Customer: PRINCETON PLASMA PHYSICS LAB

Drawing ID: SE120-004 Revision: 2
Links: 1-Type:W: 65678/2.0 Sub: 5 Op: 243

Nonconformance Report: Major Tool NC19562

This is for SE120-004 VVSA #2 end flange fit up and weld.

8 O'clock Inside of Flange B

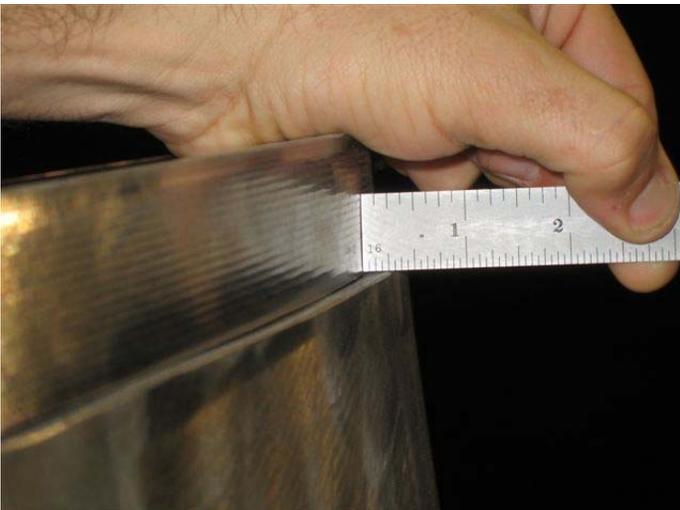
THE RESULT OF PROFILE DEVIATION ON THE VESSEL ENDS CAUSES A MIS-ALIGNMENT TO THE VESSEL FLANGES. REFER TO PHOTOS FOR ADDITIONAL DESCRIPTION.

RECOMMEND LEAVING THE VESSEL WALL IN ITS CURRENT POSITION AND ALTERING THE WELD SCHEME TO BLEND THE TWO SURFACES TOGETHER IF NO ASSEMBLY OR PLASMA INTERFERENCE EXIST

Rework as Recommended by MTM.
Ensure weld size is equal or greater to original.

8 O'Clock Inside of Flange A (nearly flush)

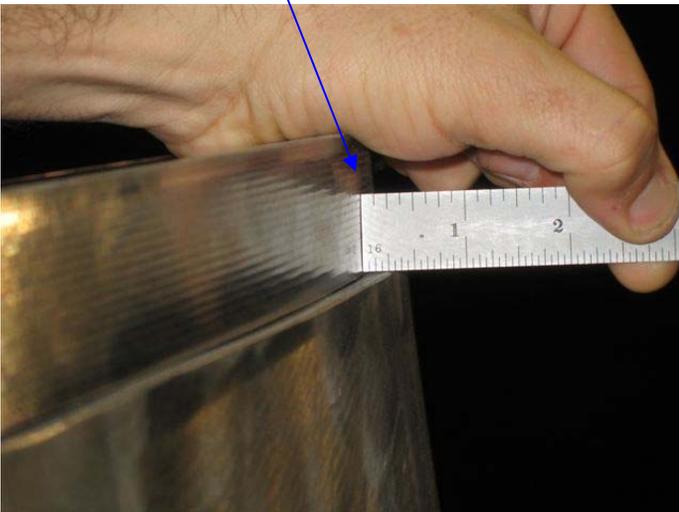
- The current flange fits up to the vessel within the profile of the vessel shell everywhere but a few locations (need to add pict.)

Will probably lose fiducial holes and clamp holes to “buttering” weld. These welds would have to be made without heavy cover plate welded on to heat sink & hold flange. Consider doing “buttering” as part of field weld process

Flange to the outside of the vessel by ~0.125-0.188 “ over a length of ~ 12 “

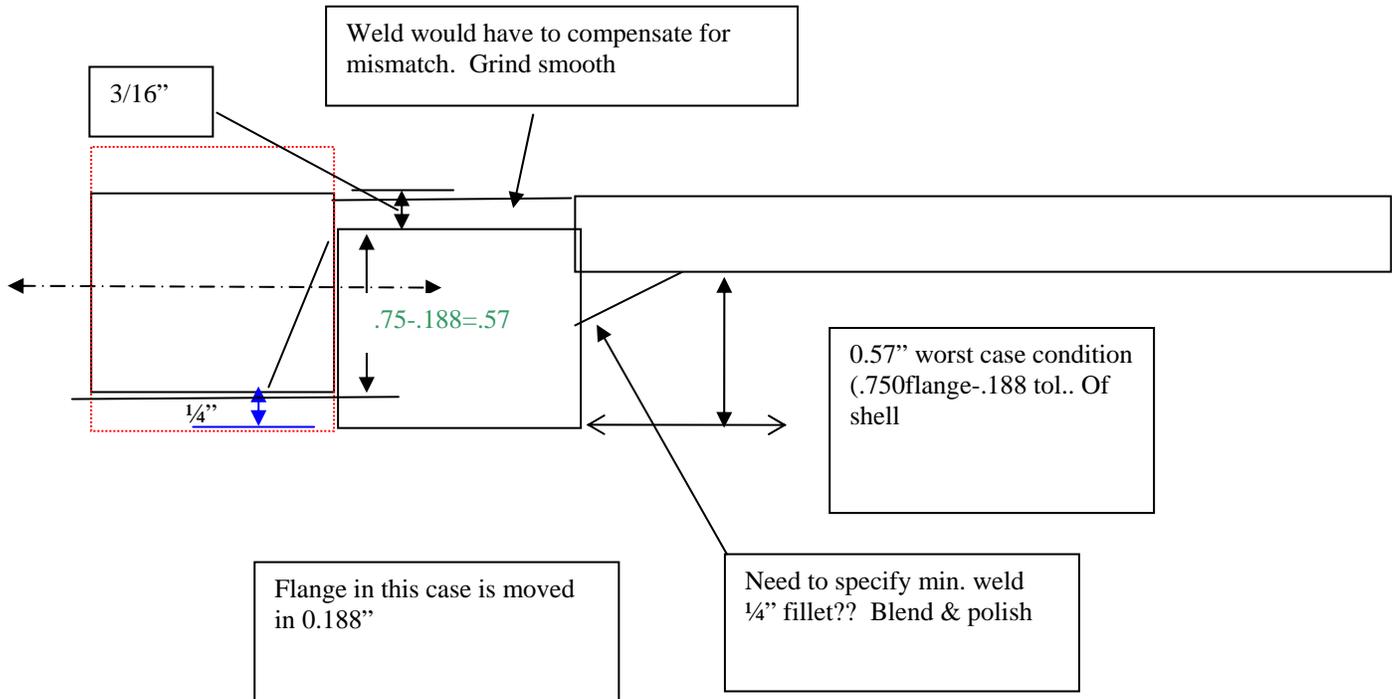
If the vessel max. outwards tolerance coincided with the flange maximum inwards tolerance, this would be the condition

For VVSA2, end A, this maximum encroachment was evaluated by Art and is acceptable in the pre-welded condition.

Assuming that field weld shrinkage might move the wall and flange inwards by another 0.010'', this would still be acceptable.

Proposed fix for VVSA #2 and #3 end flanges

A. shell outer surface is outside flange od: MTM to do the following

- Make inside weld between flange and shell and clean up
- Weld leak check cover plate on
- Finish shell to flange weld on outside and butter up od of flange to match or exceed outside surface of shell
- Perform leak check
- Remove leak check cover plate
- Clean up face surface of flanges
- $3/8$ minimum weld throat, smoothed out and blended for vacuum service on inside

B. Shell inner surface is inside of shell id:

- PPPL will butter up id of flange by carrying assembly weld over to shell
